STAFF REPORT
(One-Step Final Plat)

CASE NUMBER: SUB 2001-76 -- SHAMROCK TIRE ADDITION

VICINITY MAP

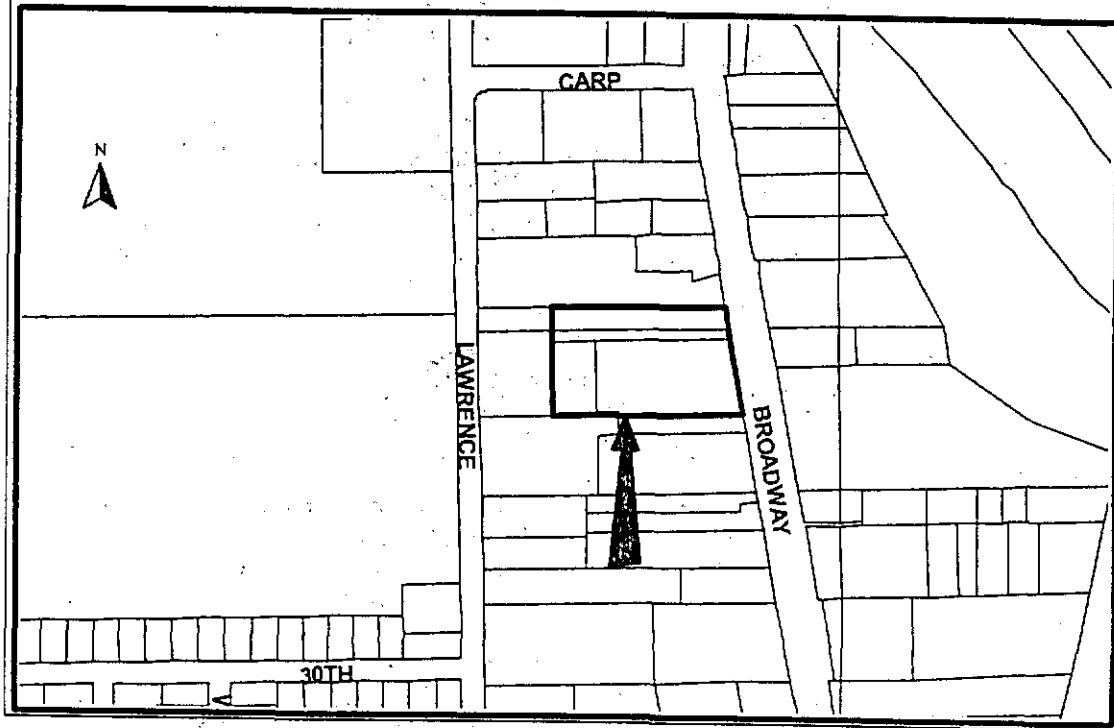
I-34
SS Easement needed
ON N & W #S
